Site Management Plan

SRSNE Superfund Site
Southington, Connecticut

PROJECT OPERATIONS PLAN
SOLVENTS RECOVERY SERVICE OF NEW ENGLAND, INC.
SUPERFUND SITE
SOUTHINGTON, CONNECTICUT

Re: SRSNE Site
RI Work Plan Addendum
Project #: 1041.08330 #2

Project Schedule

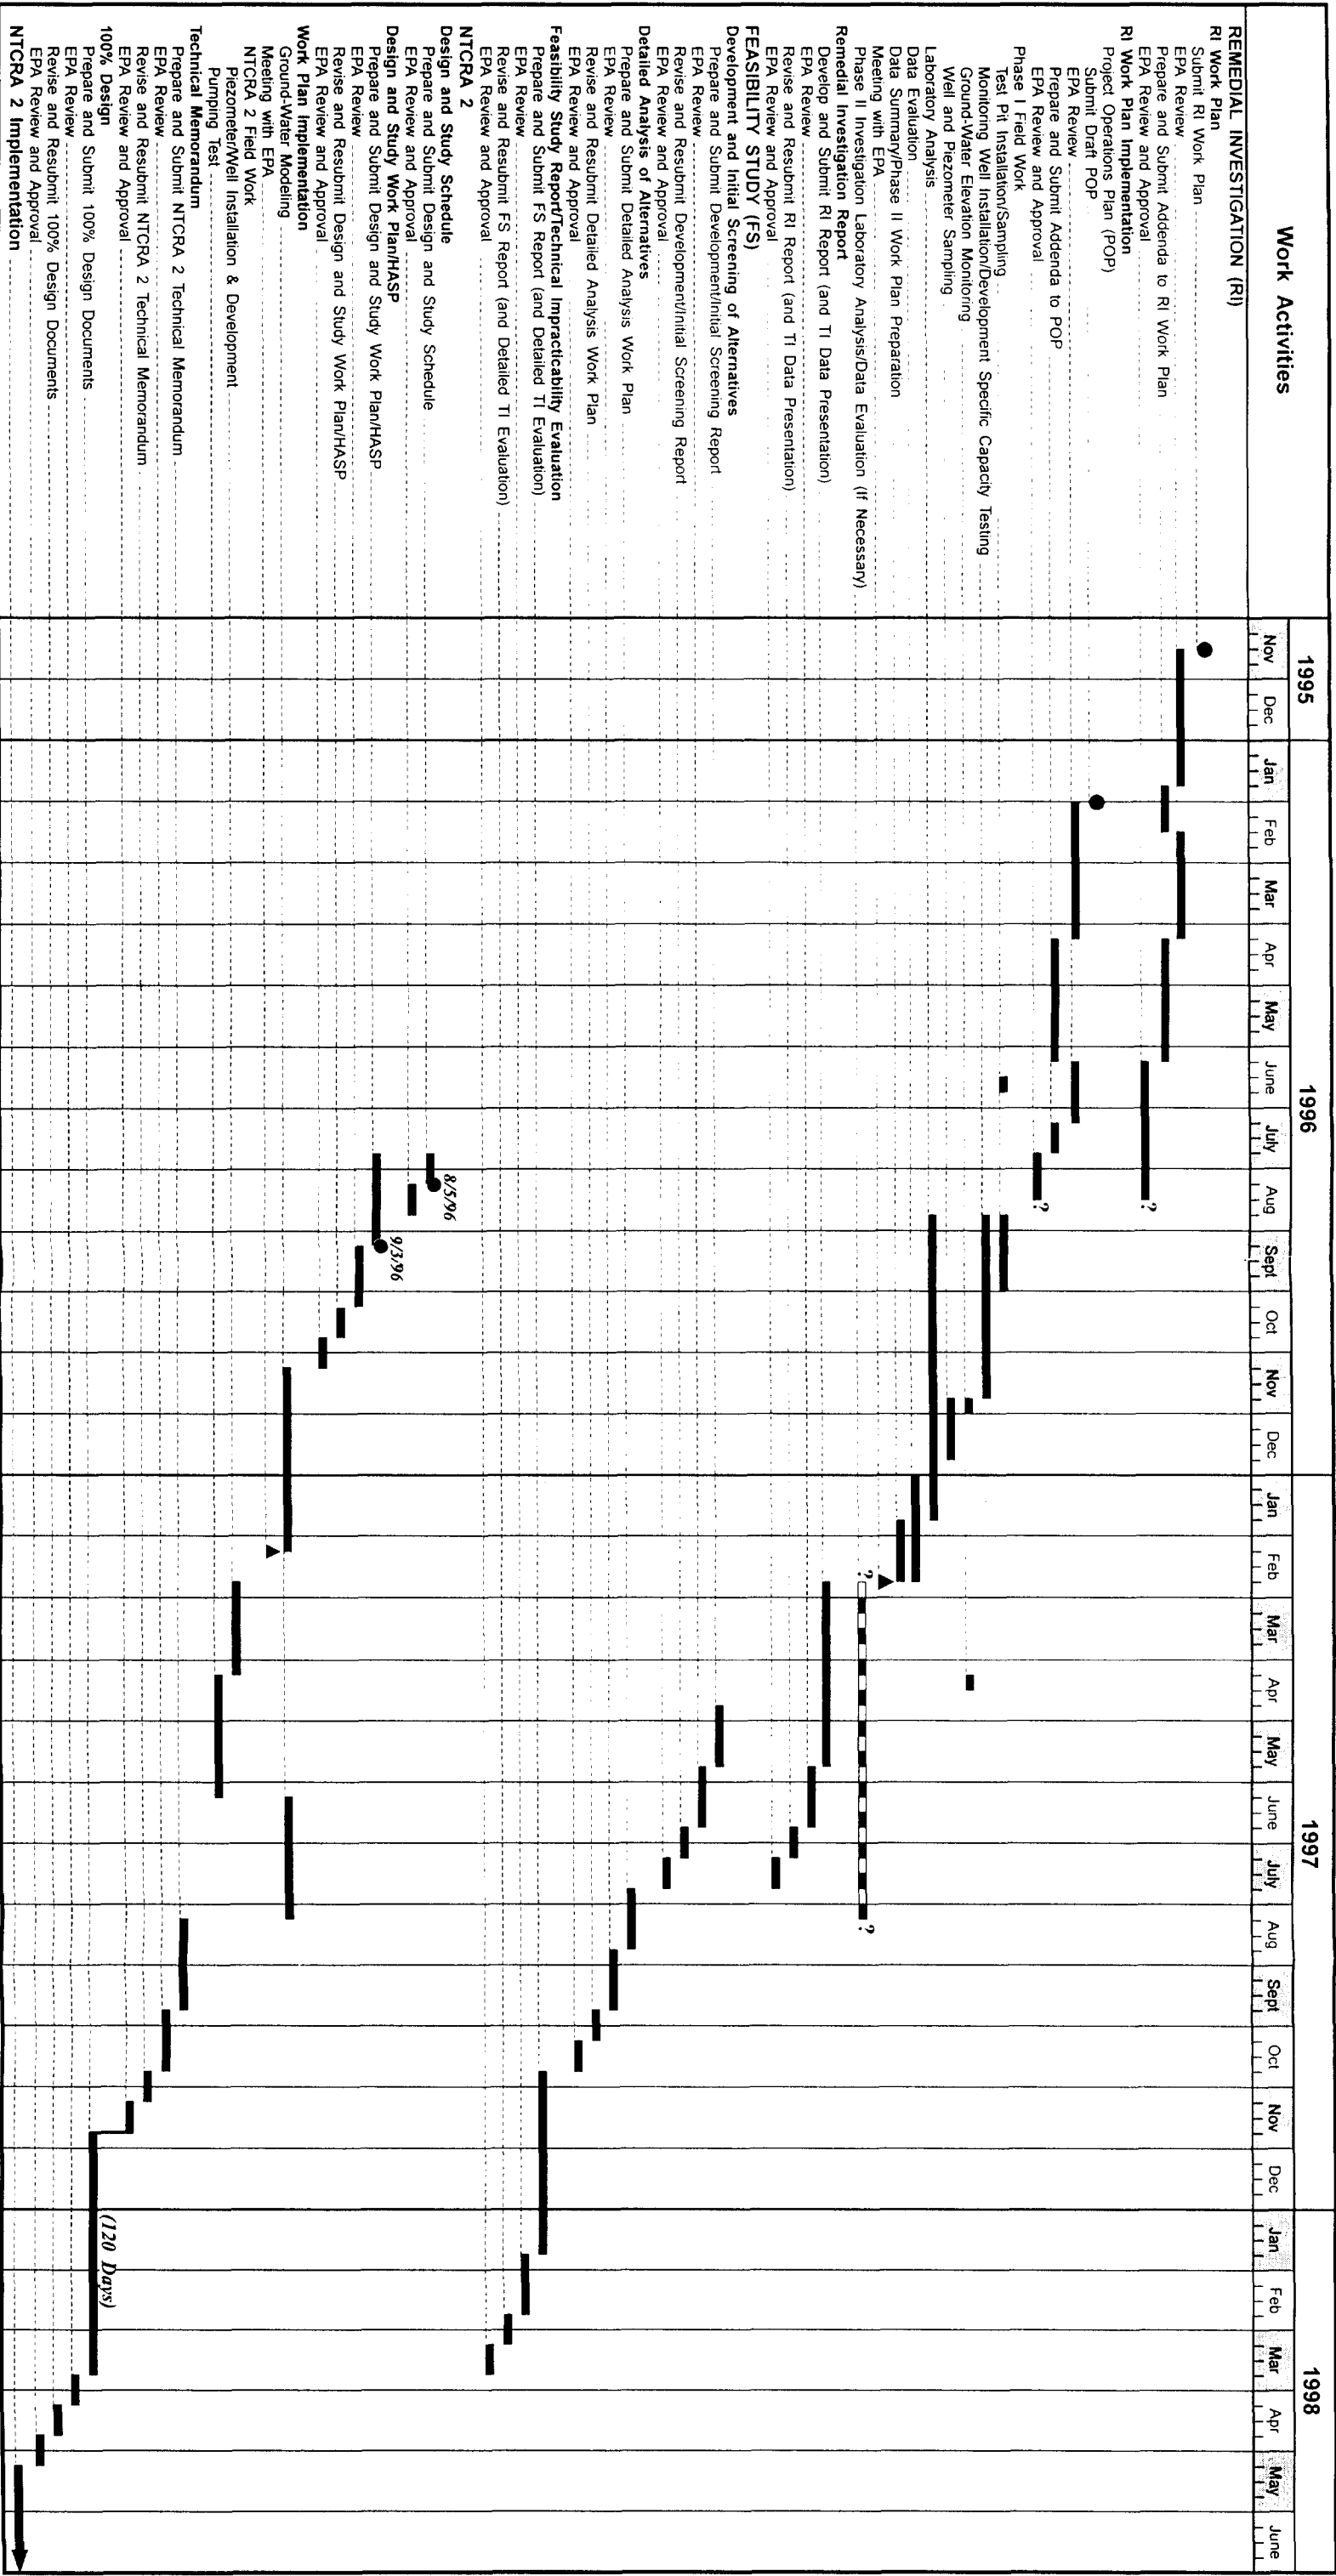
1. This plan must be revised to include project organization (proposed Figure 3), a list of subcontractors, and an updated schedule (proposed Figure 4).

1. The SMP (Attachment 2) has been revised to include project organization (Figure 3), a list of subcontractors, and an updated schedule (Figure 4).
